CONTRACT NO. 1800

WET WEATHER PUMP STATION

ADDENDUM NO. 12

Attachment C - Addendum No. 12 Drawing – 22” x 34” (1 page)

Addendum No. 12 Drawings

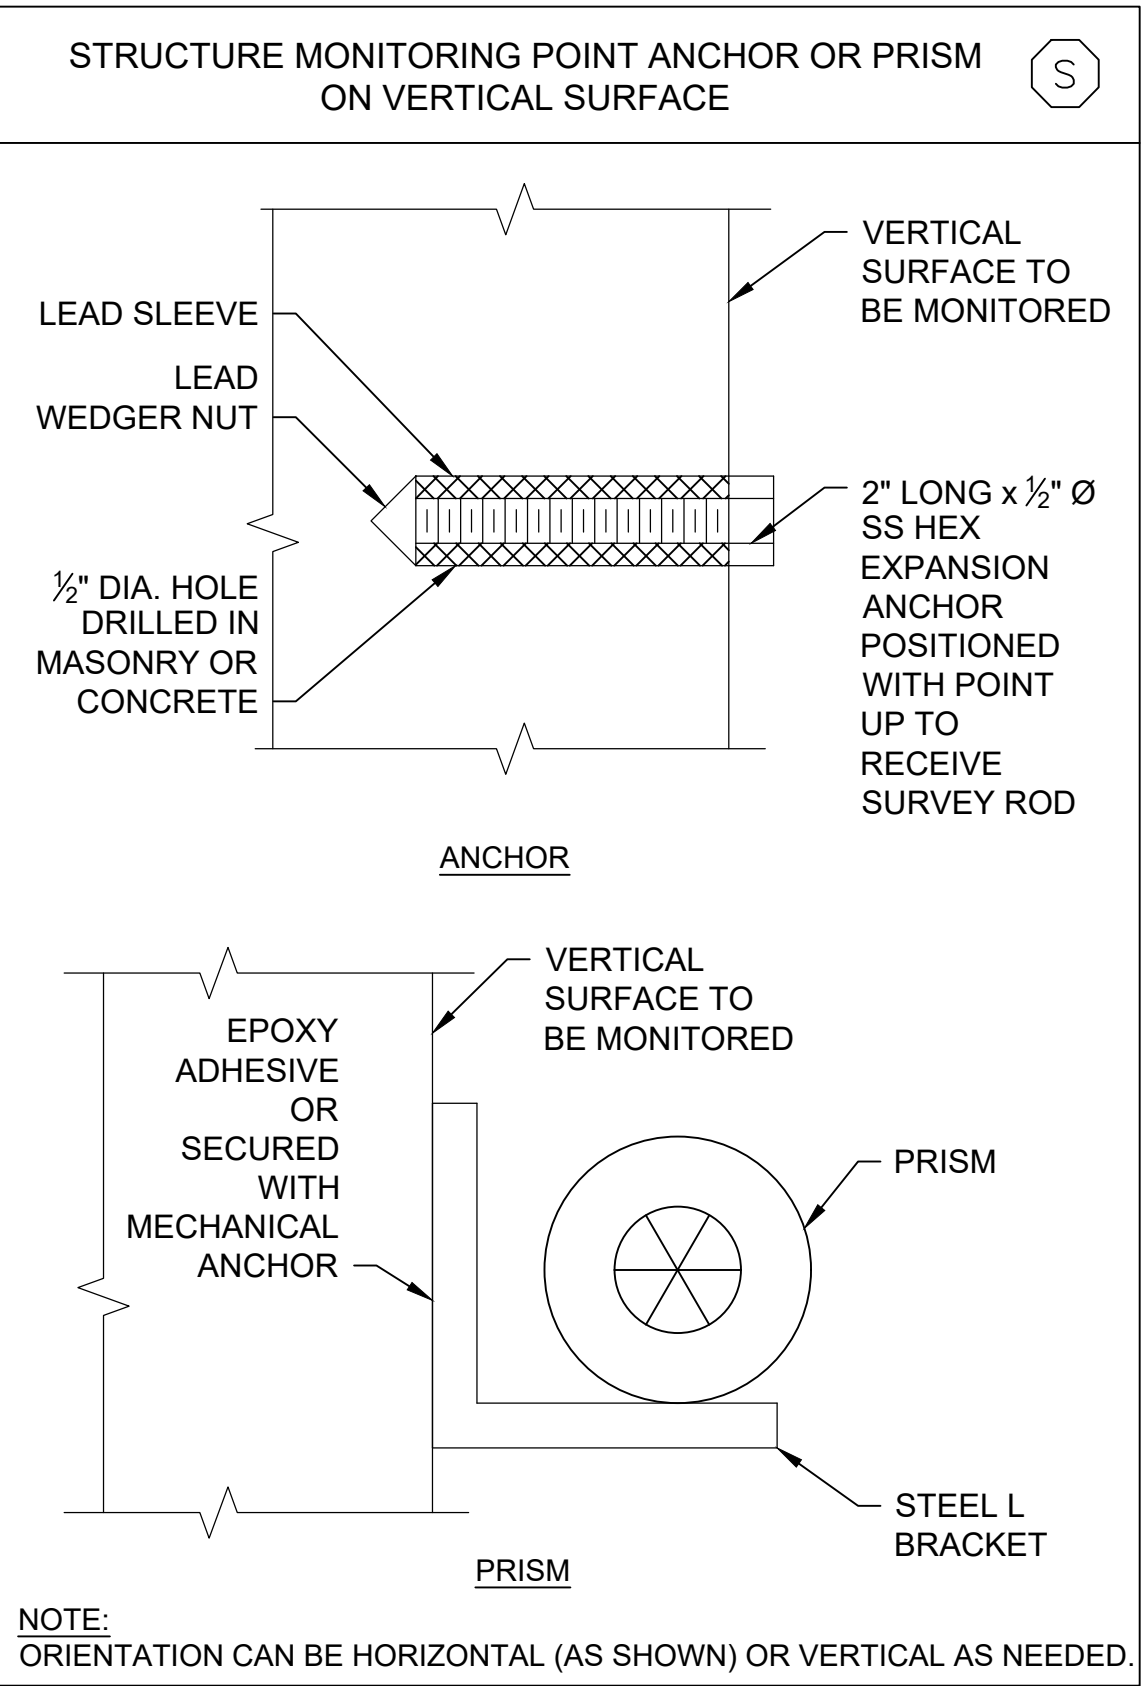
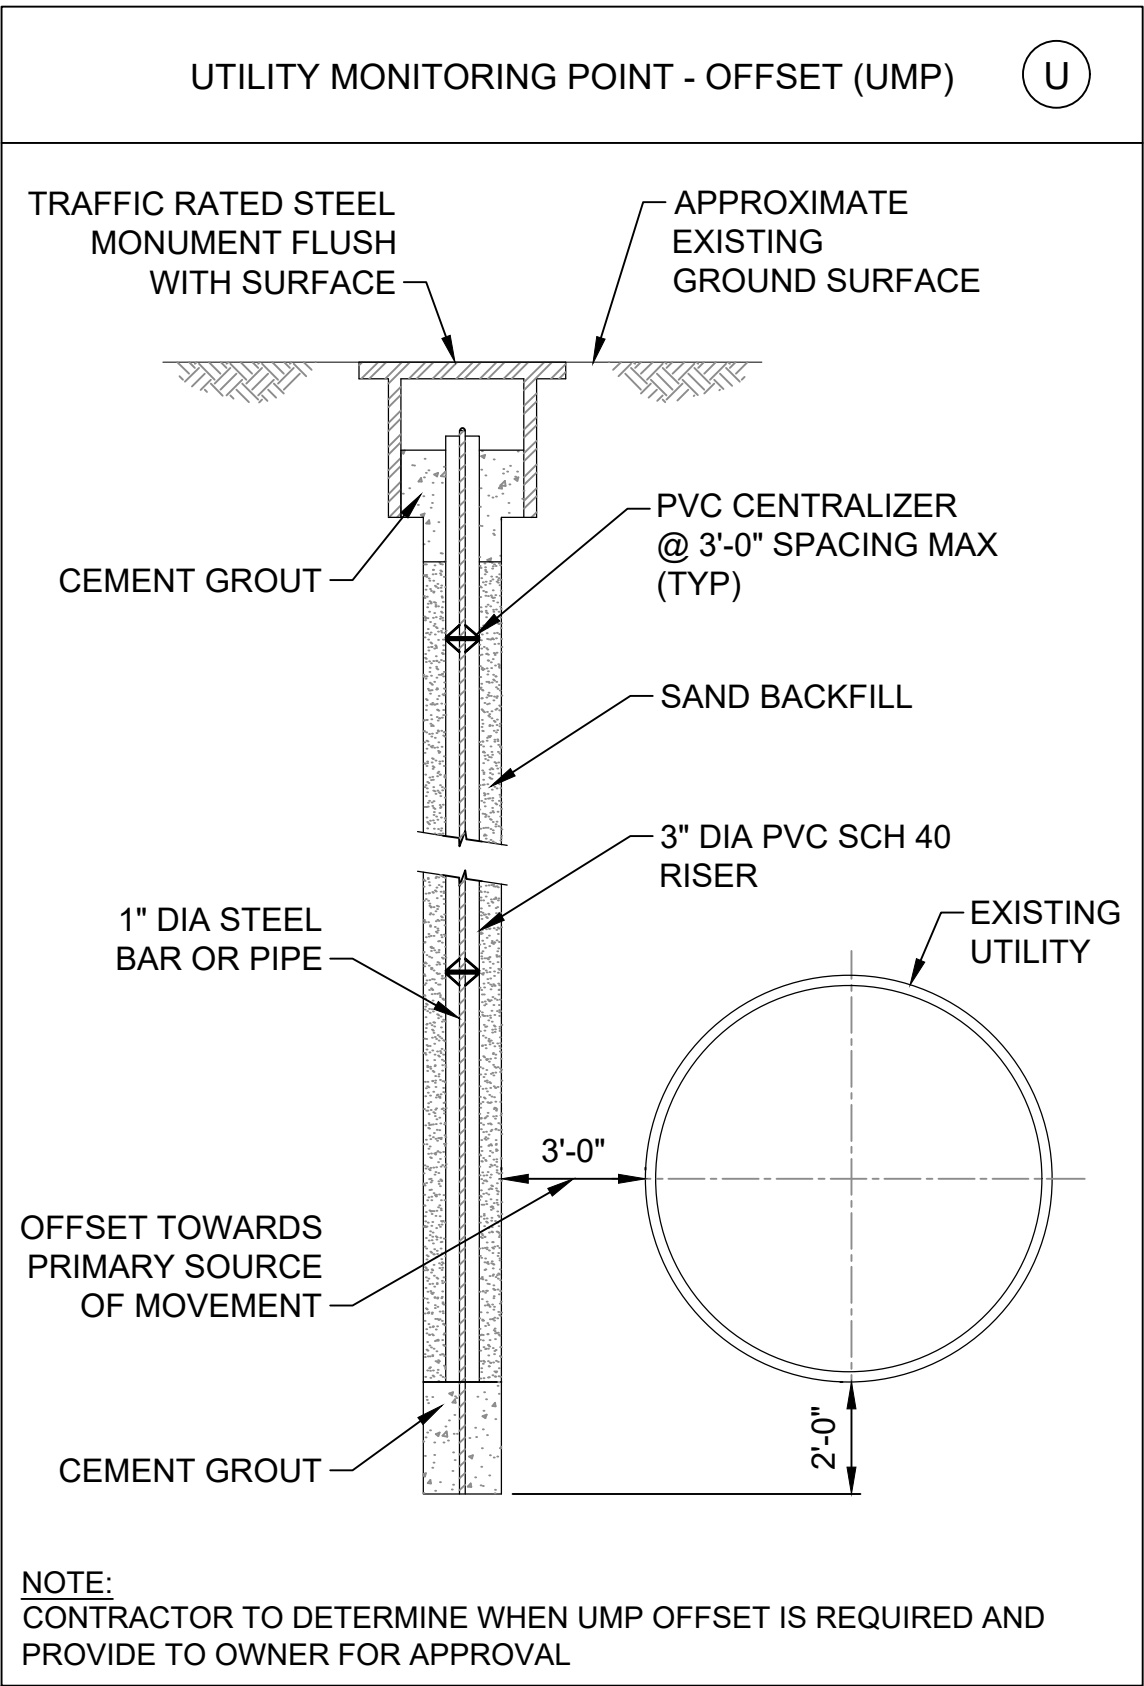
4.1 **REPLACE** Sheet 430-GT-04 with Sheet 430-GT-04 Rev.01, refer to Attachment C.

Designed by: G. ASPIRAS	REVISION				
	REV No.	DATE	DESCRIPTION	APPV	
	0	5/16/25	ISSUED FOR BID	PDC	
Drawn by: P. CAMPBELL	1	9/18/25	ADD. 12 - UPDATED NOTE ON CRACK GAUGES	PDC	
Checked by: P. CAMPBELL
